TECHNICAL BULLETIN

407-14-109

MODEL AFFECTED: 407

SUBJECT: AFT ENGINE FIREWALL ASSEMBLY,
INSPECTION, REPAIR, AND MODIFICATION OF,
FOR ENHANCED STIFFNESS.

Figure 1: Firewall, Inspection of

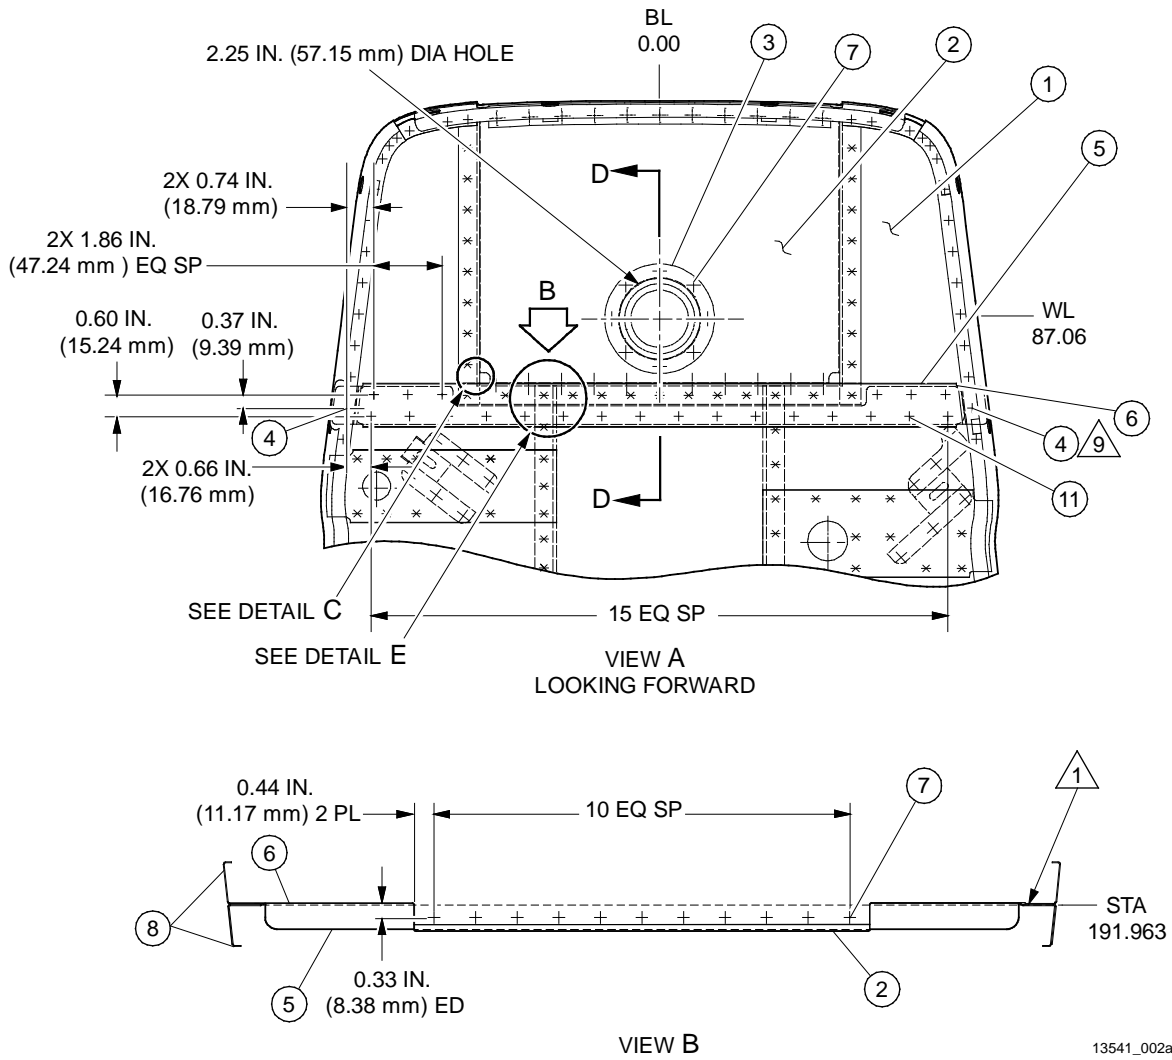
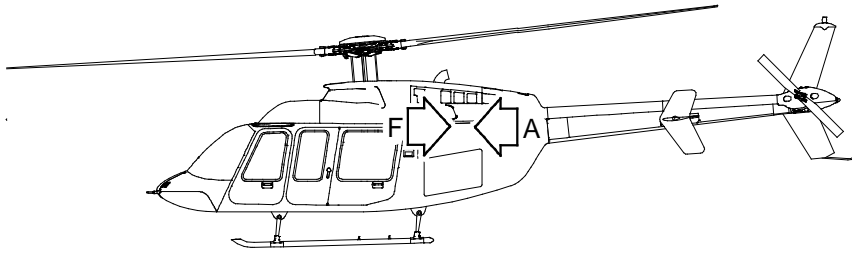
1. Prepare the helicopter for maintenance.
2. Open the engine doors and inspect the aft firewall assembly. Pay attention to the recessed section (2, Figure 1) for any signs of fretting with the fuel nozzle hose and/or the shield clamp.

- 1. Inspect this region in recessed area for possible fretting marks from fuel nozzle hose clamp.
- 2. Inspect each corner radius of web for possible crack damage.

Figure 2: Firewall, Repair and Modification of (Sheet 1 of 4)

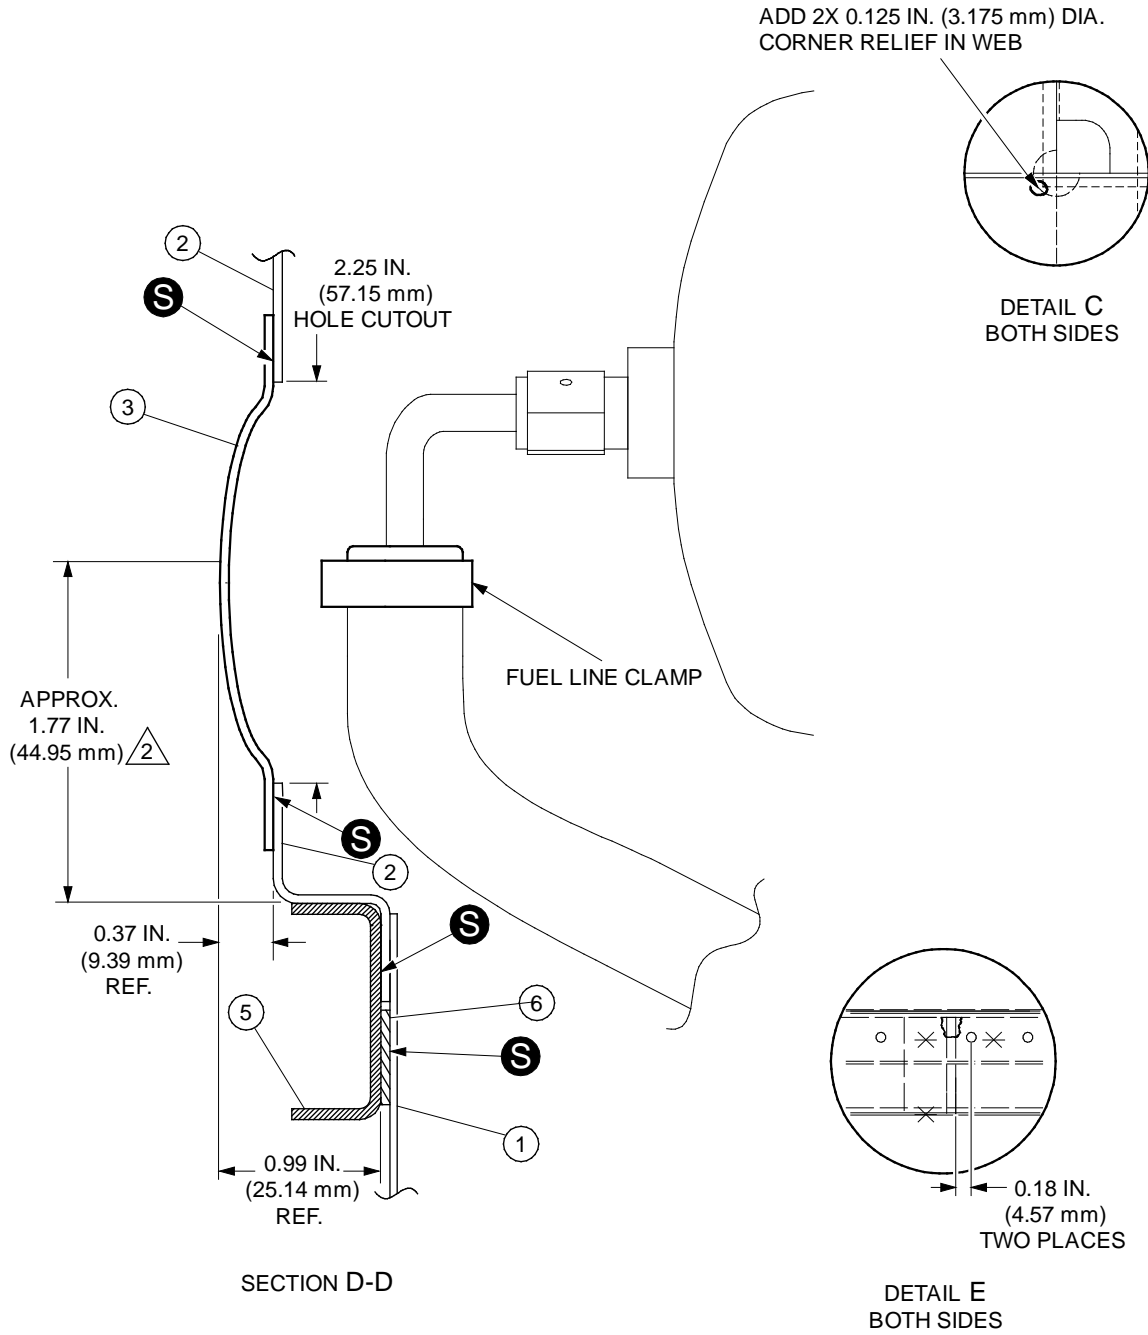
It is recommended to install the repair beaded doubler (3, Figure 2) regardless if firewall fretting with the fuel nozzle hose clamp has occurred or not.

It is recommended to install the two repair doublers (9, Figure 2), regardless if there is a crack or not, in the corner radiuses of the recessed pan. The two doublers (9) will provide added stiffness to the firewall assembly and are considered a part of the preventive measures against development of future crack(s) originating from the corner radiuses of the recessed section (2) of the firewall assembly.

- a. Mark the position of a 2.25 inch (57.15 mm) diameter circle (Figure 2). If fretting did occur between the recessed section (2) of the firewall assembly and the engine fuel nozzle hose clamp, it is acceptable to center the 2.25 inch (57.15 mm) diameter hole on the existing fretting mark(s).
- b. Cut the hole in the web and deburr the edges.
- c. Center the beaded doubler (3) with the new hole made in the web of the recessed area (2) and drill eight rivet holes.

- d. Coat the faying surfaces of the doubler (3) and the aft face of the firewall recessed area (2) with sealant (C-353). Install the doubler (3) in place on aft side of the firewall with eight rivets (7) wet with sealant (C-353).
4. Inspect the complete firewall assembly for additional damage and cracks. Pay close attention to the two corner radiuses where the recessed area (2, Figure 1) begins in the firewall assembly (Note 2, Figure 1).
- a. If no crack exists, route each corner of the web (1) near the recessed area (2) (Detail C, Figure 2).
 - b. If crack(s) originated from the corner radius where the recess area (2) begins, proceed as follows;

Figure 2: Firewall, Repair and Modification of (Sheet 2 of 4)

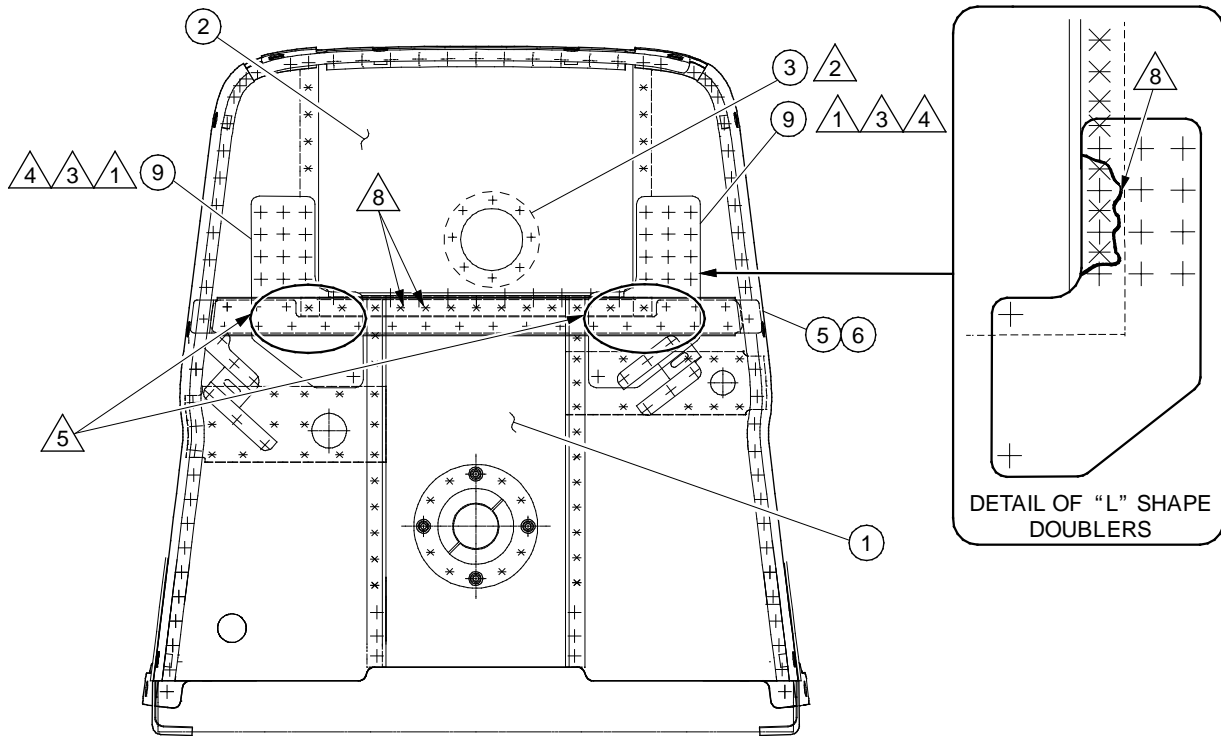
- a. Position the shim (6) and the stiffener (5) on the aft face of the web (1). Make sure it is tight against the lower flange of the recessed area (2).
- b. Position the two doublers (9) on the forward face of the web (1) and secure with clecos.

- d. Remove the doublers (9), as applicable, shim (6), and stiffener (5). Deburr all the holes.
 - e. Coat the faying surfaces of the doublers (9), as applicable, stiffener (5) and shim (6) with sealant (C-353). Install in place with wet rivets (4, 7, and 11).
6. Make an entry in the helicopter logbook and historical service records indicating compliance with this Technical Bulletin.

Figure 2: Firewall, Repair and Modification of (Sheet 3 of 4)

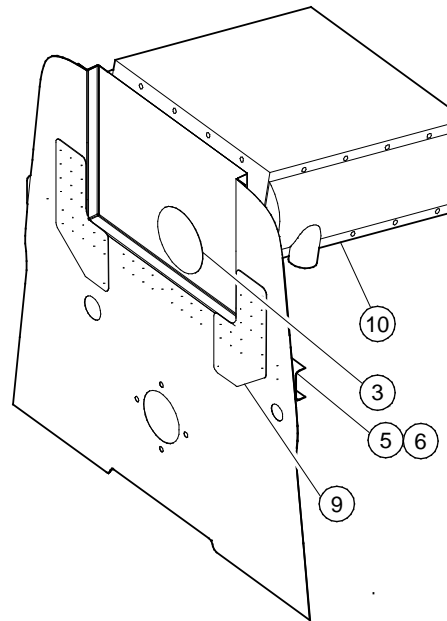
VIEW F
PARTS OVERLAYED
FOR FASTENER POSITIONS
LOOKING AFT

Figure 3: Details of Stiffener, Shim and Doublers (Sheet 1 of 2)

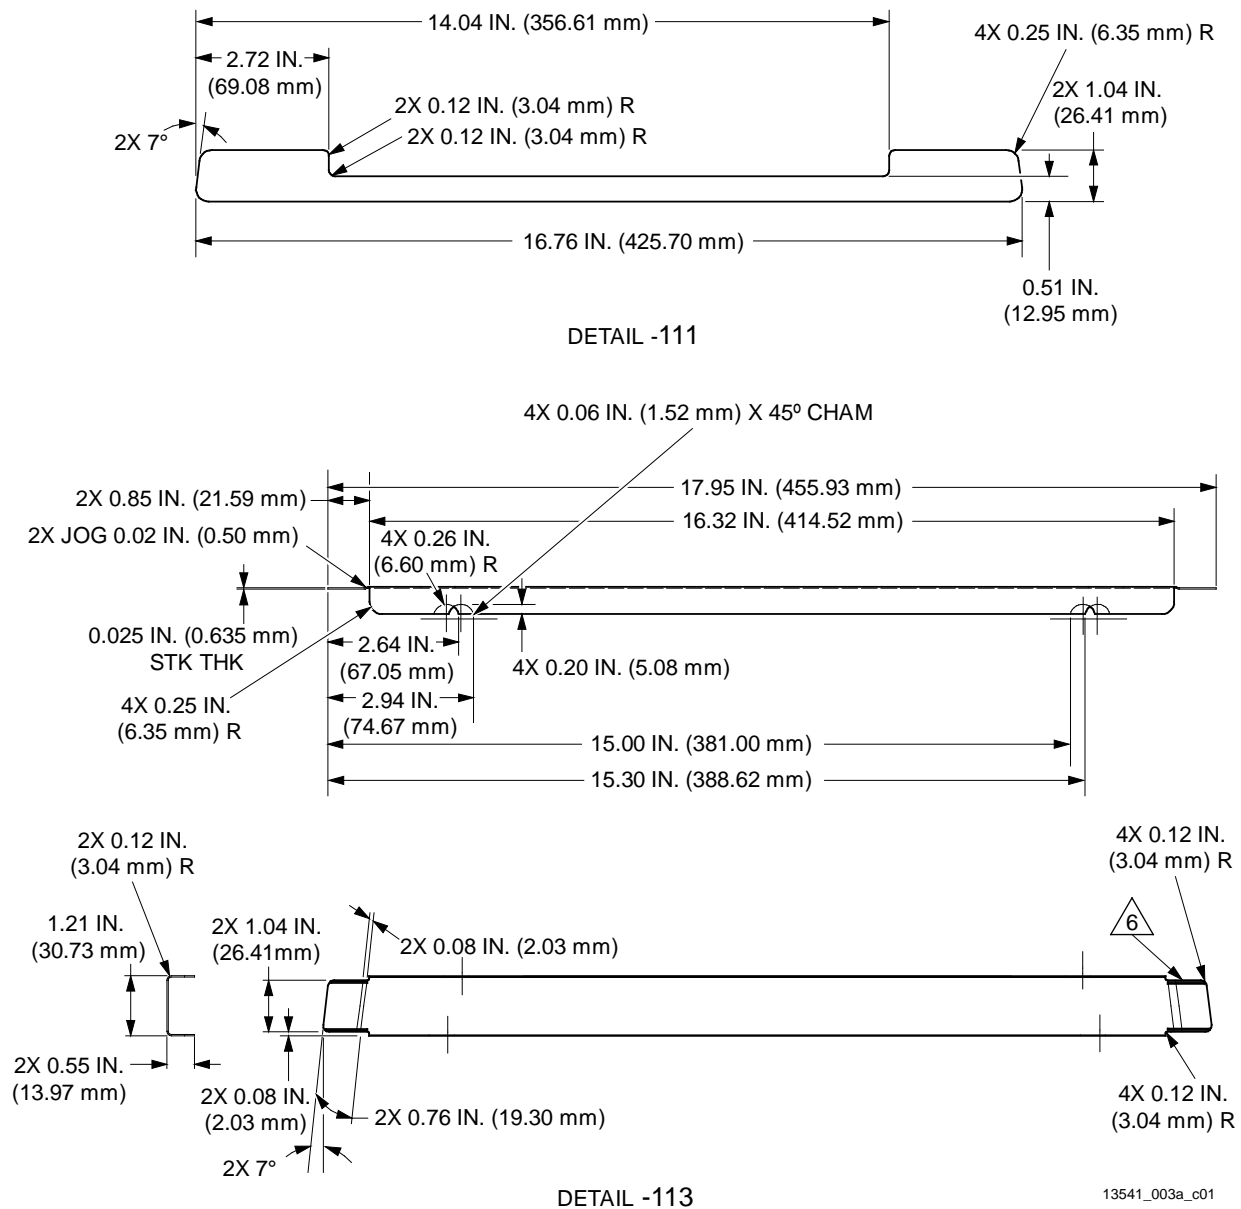
Doublers (9) are not procurable from BHT spares and shall be fabricated locally (see details in Figure 3).

The stiffeners (5) and the shim (6) can be fabricated locally per details in Figure 3 or procured directly from BHT approved spares (see Material Section of this bulletin).

1. Order shim -111 from Bell Helicopter Textron spares or make locally, using 301 Cres material, per AMS5517, 1/4 hard, 0.020 inch (0.508 mm) thick.
2. Order stiffener -113 from Bell Helicopter Textron spares or make locally, using 301 Cres material, per AMS5517, 1/4 hard, 0.025 inch (0.635 mm) thick.
3. Make doublers locally (non-procurable from Bell Helicopter Textron spares) using 301 Cres material, per AMS5517, 1/4 hard, 0.020 inch (0.508 mm) thick.
4. All bend radiuses to be 0.16 inch (4.06 mm).
5. Break all sharp edges 0.015 inch (0.381 mm) x 45° or 0.015 inch (0.381 mm) radius.

Figure 3: Details of Stiffener, Shim and Doublers (Sheet 2 of 2)

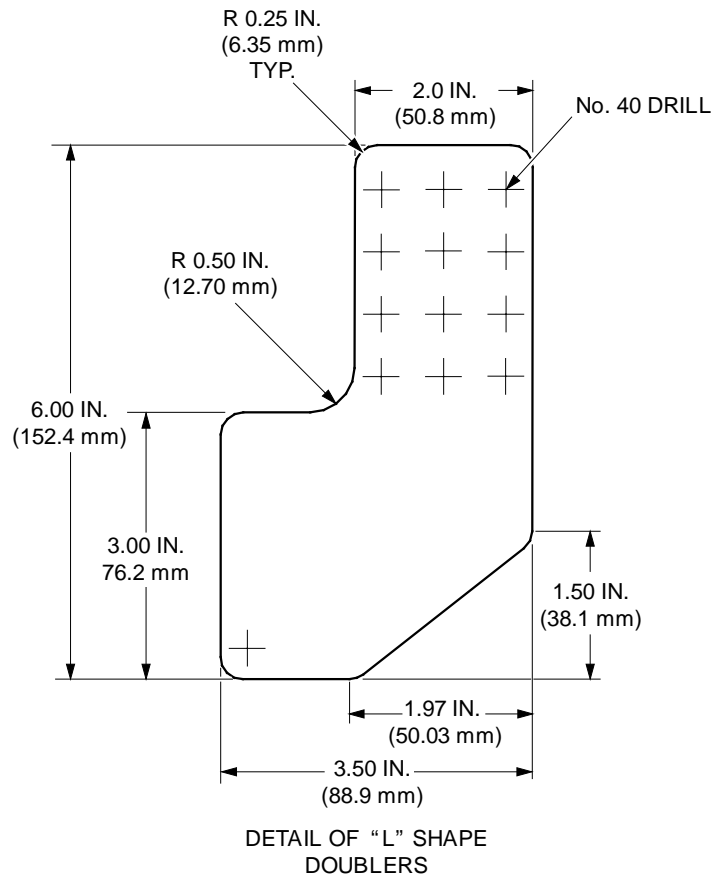
It is permitted to trim the stiffener in shaded areas to allow clearance with rivets in the firewall. Ensure edge distance of 2D for all rivets passing through the stiffener.
